**AA4 submission No. 5:
Western Power's proposed price control mechanisms**

11 December 2017

1 EXECUTIVE SUMMARY

Figure 2: WP's energy consumption forecasts

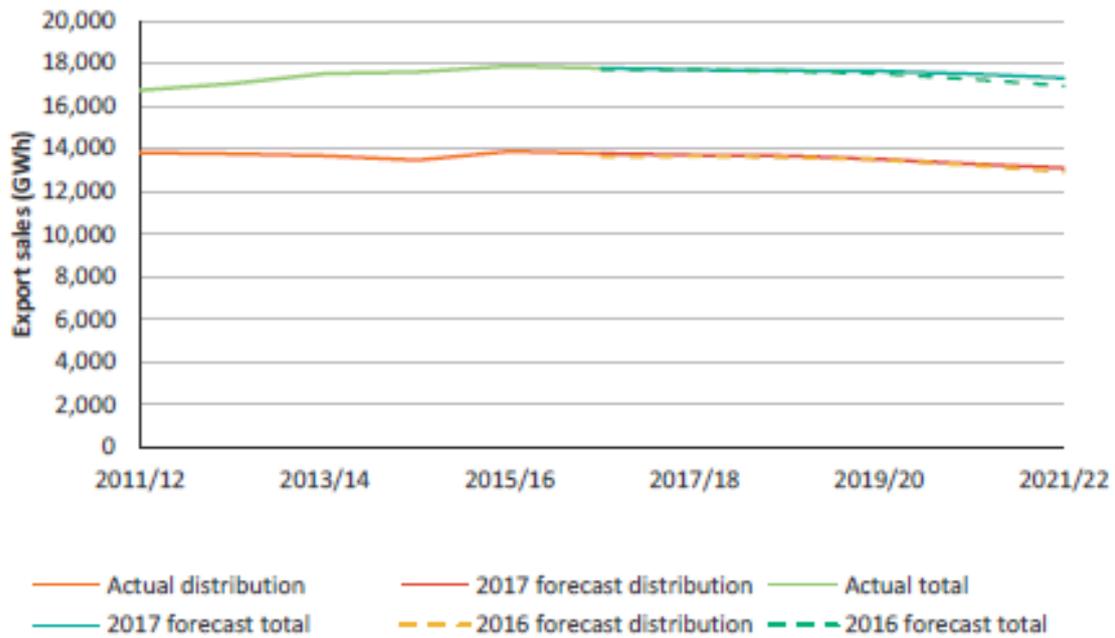
- Synergy notes WP's forecasts of energy supplied by the distribution network from 2015, 2016 and 2017 have been remarkably consistent. Comparing the three forecasts for 2018 and for 2021 Synergy finds the forecasts have varied by less than 0.5%. Over the three year period Synergy would have expected that revised forecasts of relevant drivers of energy – including economic activity, prices, housing commencements and the adoption of rooftop solar PV – would have resulted in more material revisions to these forecasts. In comparison, it appears to Synergy that AEMO's forecasts have been much more responsive to changing circumstances over time. But, without a more detailed understanding of the methodology and assumptions used to forecast energy it is impossible for the Authority, Synergy or other stakeholders to assess whether these energy forecasts are reasonable.

Figure 3: WP's peak demand forecasts

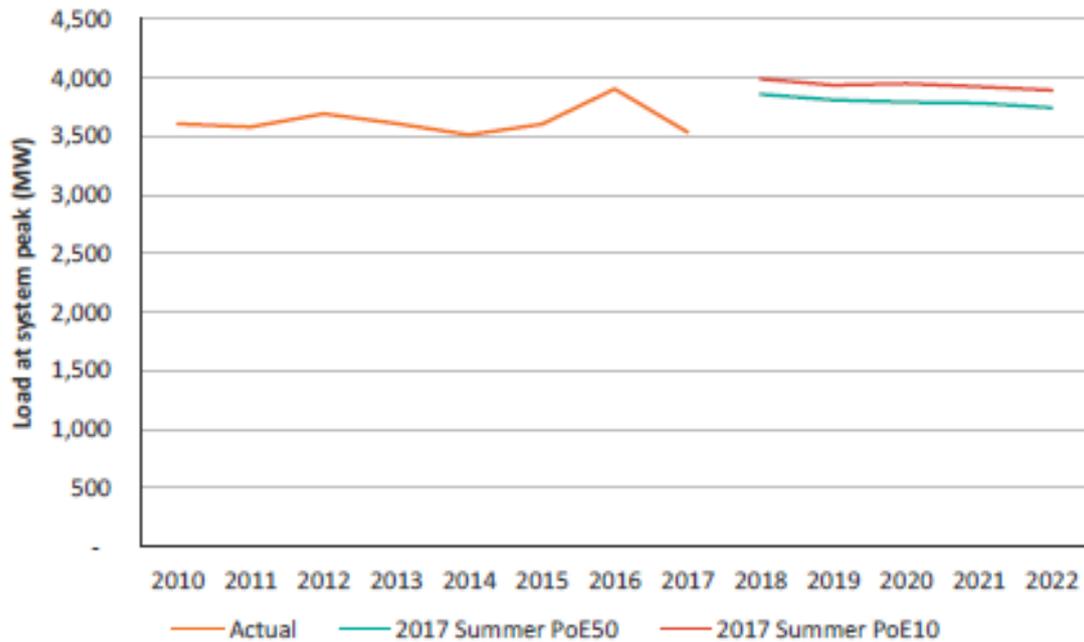
- Synergy notes WP's 2017 summer POE50 peak demand forecast for 2018 is higher than all but one of the actual peak demands recorded over the eight years from 2010 to 2017 and WP's 2017 summer POE10 peak demand forecast for 2018 is higher than any of the actual peak demands recorded over those eight years. In simple terms, it would be expected that a POE50 forecast would be exceeded one year in two and a POE10 forecast would be exceeded one year in ten. There may be a reasonable explanation for the 2018 forecasts seeming to be relatively high compared with actual peak demand; for instance, weather normalised actual peak demand may have reached higher levels or relevant drivers of peak demand may explain these apparently high forecasts. But, without a more detailed understanding of the methodology and assumptions used to forecast peak demand it is impossible for the Authority, Synergy or other stakeholders to assess whether these peak demand forecasts are reasonable.

Figure 4: WP's capex forecast for AA4, compared with actual capex for AA3

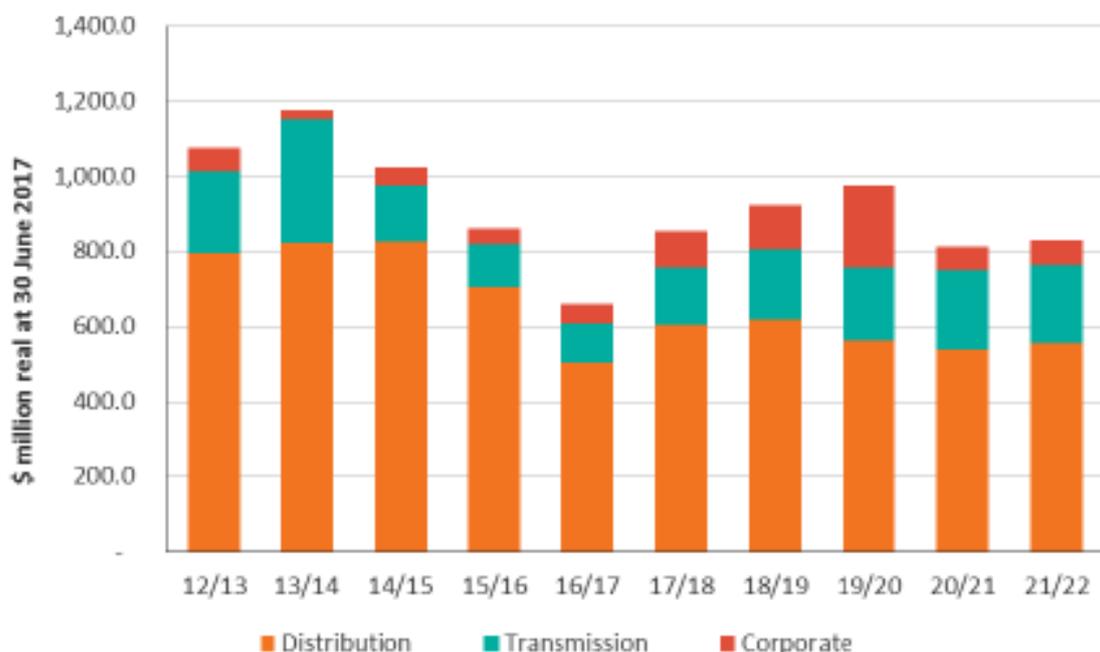
In addition to these specific comments, Synergy considers WP has not provided sufficient detail regarding its capex forecasts. Synergy notes the AAI Guidelines require that information supporting forecasts of costs must include:

- the assumptions on which forecasts are based;
- a full and detailed explanation of the basis of preparation of the forecasts; and
- evidence to show the forecasts only include costs which would be incurred by a service provider efficiently minimizing costs.

Figure 5: WP's service performance capex forecast for AA4, compared with actual capex for AA3

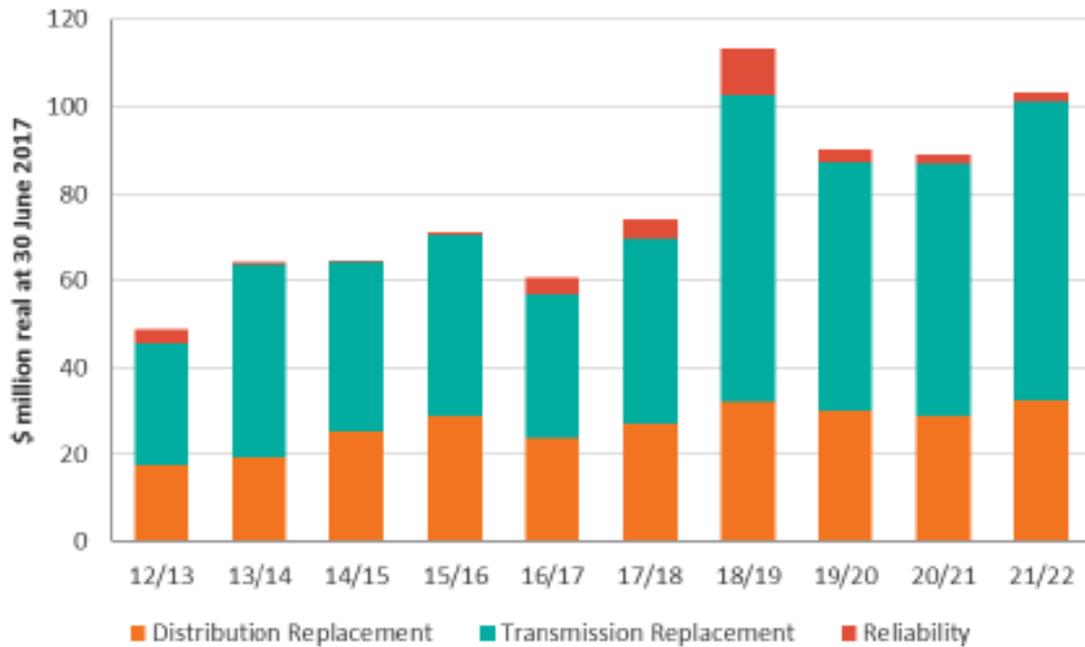
WP proposes to increase capex focused on maintaining service levels during AA4 relative to AA3, as seen in Figure 5. WP notes customers are generally satisfied with overall current levels of performance and so WP's forecast service performance capex for AA4 is focused on maintaining services levels that were achieved in AA3. It is unclear to Synergy (and WP has not adequately explained) why service performance capex would need to be so much higher in AA4 than in AA3 just to maintain the same level of service performance. This appears to suggest the underlying operations and investments may not be consistent with section 2.1 of the Code and may be a result of cross subsidisation between the transmission, distribution and metering businesses. In Synergy's view, the Code contemplates all three businesses should be efficient and one business unit should not compensate for inefficient decisions or operations in the other business units.

Further, in light of WP's proposed transmission price path, Synergy submits the Authority should determine what level of "cross subsidised operational or investment arrangements" exists, if any, in relation to investment and operation of the transmission, distribution and metering business is consistent with the Code objectives. Synergy also submits the Authority should determine what information must be provided by WP under section 4.2 of the Code so users and the Authority can understand how these arrangements are consistent with the Code and require WP to provide that information. For example, if proposed investment in the metering business is subsequently decided to be reallocated, for commercial reasons, to the transmission business or vice versa.

Figure 6: WP's growth-rated capex forecast for AA4, compared with actual capex for AA3

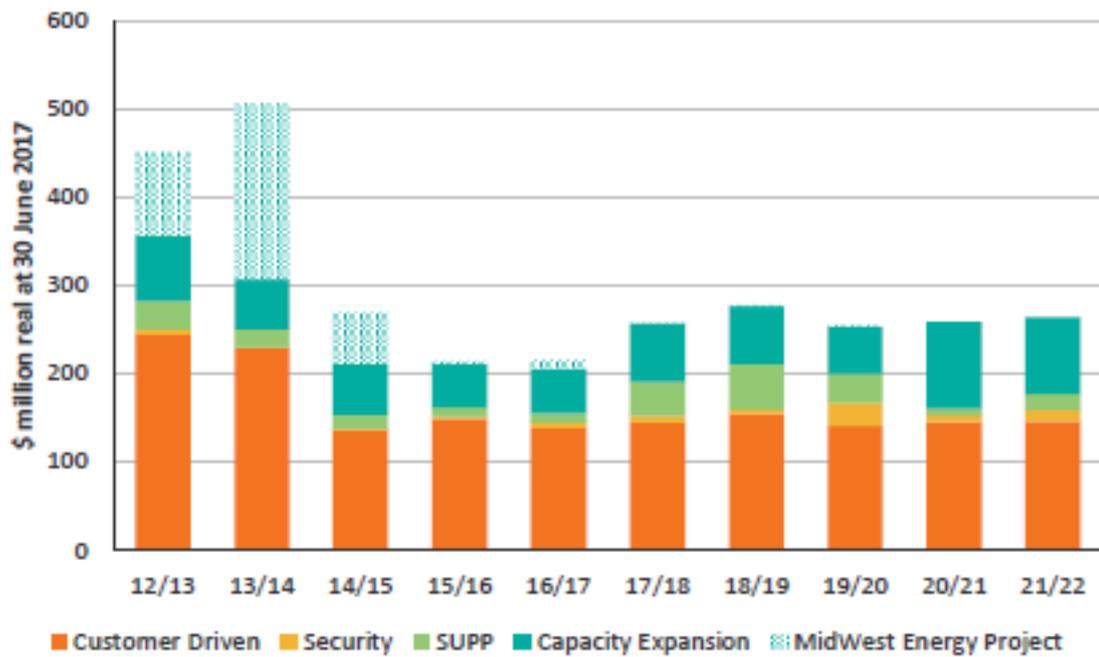
WP notes during the course of AA3 the total capital investment was 22% less than included in the AA3 target revenue. WP states this lower capex was driven by a slowdown in the growth rate of peak demand, a reduction in customer-driven work, a risk-based approach to asset management and process improvements as a result of WP's Business Transformation Program.

However, for AA4, WP is forecasting a pick-up in growth-related capex relative to that in 2015/16 and 2016/17, as seen in Figure 6. This is despite the fact WP is forecasting peak demand will fall over the period of AA4 and that peak demand is forecast to be well below the levels forecast during AA3. It is unclear to Synergy (and WP has not adequately explained) why the rate of growth-related capex would need to increase (relative to growth-related capex in 2015/16 and 2016/17) if peak demand is forecast to be lower than during AA3 and falling over the period of AA4.

Figure 7: WP’s capex forecast for AA4 for improving operation efficiency, compared with actual capex for AA3

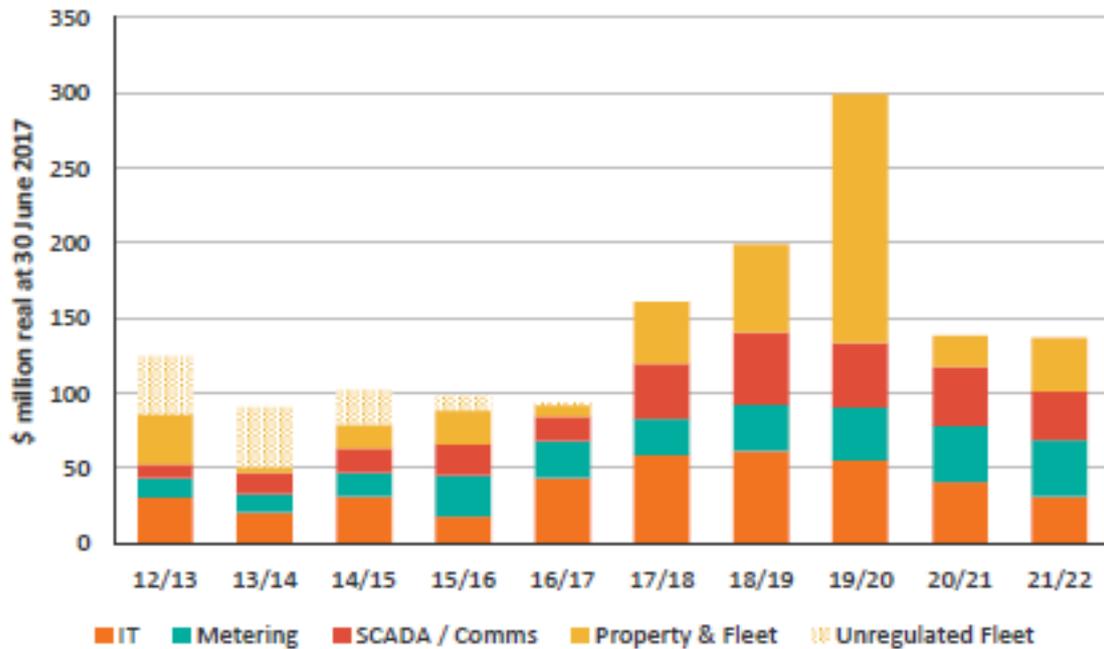
WP proposes a material increase in capex that is designed to improve operational efficiency as part of AA4, as seen in Figure 7.

In Synergy’s view, it is unclear how the benefit of these latter two justifications will flow through to customers. It is unclear WP’s proposed amount for replacement capex reflects any extension to asset life and it is unclear WP’s proposed opex amount reflects operating efficiencies as a result of the investment in SCADA and communications equipment. Synergy submits WP has not provided adequate information to explain or justify the above matters and the Authority should require WP to do so.

Figure 8: Comparison of transmission price paths

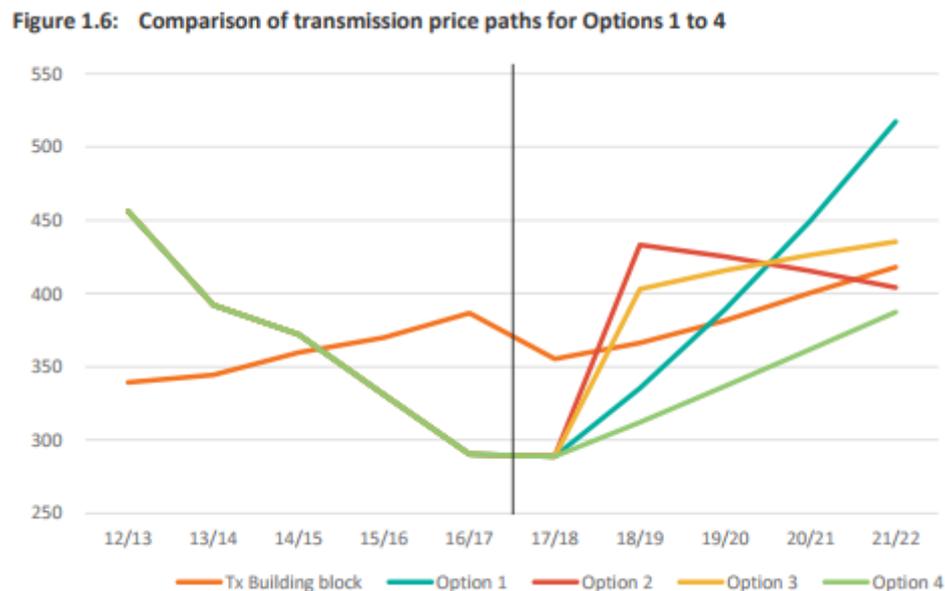
Adopting revenue smoothing is an important mechanism to manage the impact of price movements on customers between and during access arrangement periods and is consistent with best practice. Revenue smoothing is consistent with the Code and in particular sections 7.4(c) and (d) of the Code which require tariffs to be predictable and price shocks to be minimised.

There is a range of methodologies that could be used to implement smoothing and the Code is not prescriptive about the preferred approach. WP’s proposal involves revenue smoothing to ensure constant average price increases. This ensures predictability and limited price variation within the AA4 period. For these reasons, Synergy supports this approach, subject to the proviso that Synergy does not support deferral of transmission revenues to AA5 (refer to Section 3.7 above). Synergy therefore supports Option 1 in Figure 8 (below).
